MNR Sweaters Ltd Extension Building

Holdings No-467, Block-G, Ward-7, Sreepur, Baraiderchala, Gazipur

12 February 2024

2. Observations:

Figure 3.1.1: Foundation Layout Plan

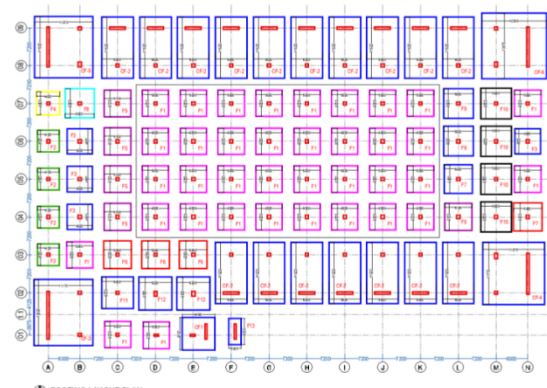
- The lateral load-resisting system is considered a Building Frame System, where 93% of the seismic force is resisted by shear walls in the X direction and 94% of the seismic force is resisted by shear walls in the Y direction. Building engineer is required to check and confirm whether the remaining lateral forces taken by the shear walls or other framing systems can be considered in the design or not.
- Combined footing adequacy check not provided in the design report, also the foundation is not checked against lateral loading.
- Shear Wall adequacy check and seismic detailing confirmation of SW not included in the design report.

Observation	Action Plan	Timeline
Factory Building		
Inconsistency in design report. (Factory Building)	Building engineer is required to check and confirm whether the remaining lateral forces taken by the shear walls or other framing systems can be considered in the design or not.	within 6 weeks
	Building engineer is required to prepare the design report according to the BNBC 1.9	within 6 weeks
	Carry out remedial work if required.	within 6 months
Possible vehicle impact on the column. (Factory Building)	The building engineer is required to provide vehicle impact protection on the ground floor column.	within 6 weeks
Anchorage of nonstructural elements (Factory Building)	Building engineer is required to adequately anchor and brace all non-structural elements to resist earthquake forces.	within 6 months
Facility Building		
Inconsistency in design report. (Facility Building)	Building engineer is required to prepare the design report according to the BNBC 1.9	within 6 weeks
